ENVIRONMENTAL PROTECTION AGENCY**40 CFR Part 52**

[EPA-R08-OAR-2010-0406; FRL-9648-3]

Approval and Promulgation of Implementation Plans; North Dakota; Regional Haze State Implementation Plan; Federal Implementation Plan for Interstate Transport of Pollution Affecting Visibility and Regional Haze**AGENCY:** Environmental Protection Agency (EPA).**ACTION:** Final rule.

Figure 1. Coal-Fired Boilers Operating Below 0.17 lb/MMBtu

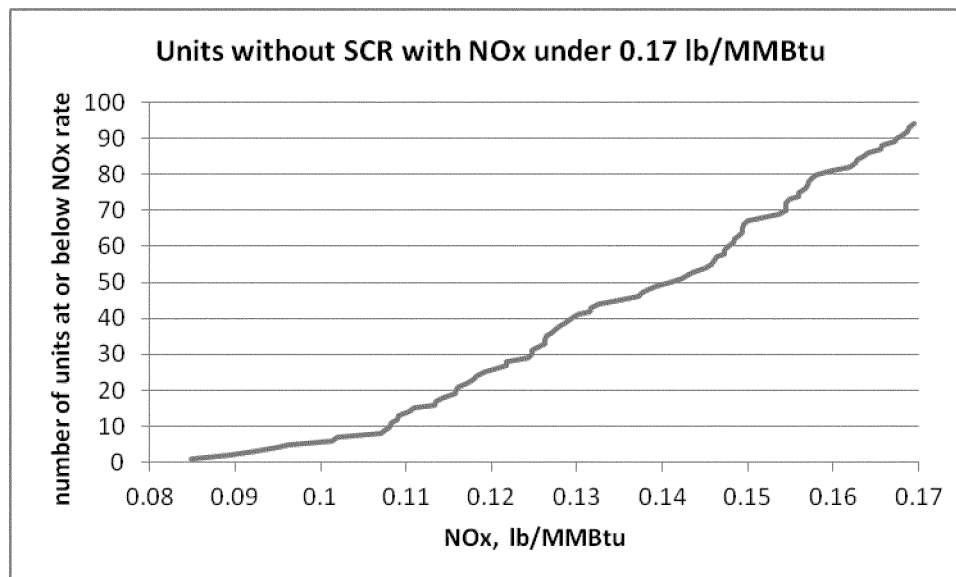
Analysis of emissions data found significant discrepancies in Figures 2.2 and 2.3 of GRE's November 2011 Refined Analysis. A review of EPA Title IV data for 2010 showed 94 coal-fired boilers that do not have SCR achieve annual emissions levels below 0.17 lb/MMBtu, with the median slightly under 0.14 lb/MMBtu (see Figure 1 below). Of these, ten of them are using SNCR in combination with combustion controls to achieve under 0.17 lb/MMBtu. See docket for a list of these facilities. Of these ten, three are supercritical tangentially-fired boilers that use lignite coal with emissions below 0.14 lb/MMBtu. These include Big Brown 1 and Monticello 1 and 2, as discussed earlier in our responses. In addition, the NEEDS Database v.4.10 for the Final Transport Rule in the CSAPR docket includes two tangentially-fired coal/steam units from North Carolina with LNC3 and SNCR that had emission rates of 0.159 lb/MMBtu and 0.164 lb/MMBtu.

As we explain elsewhere, we have decided to revise the BART limit from 0.12 lb/MMBtu to 0.13 lb/MMBtu on a 30-day rolling average.
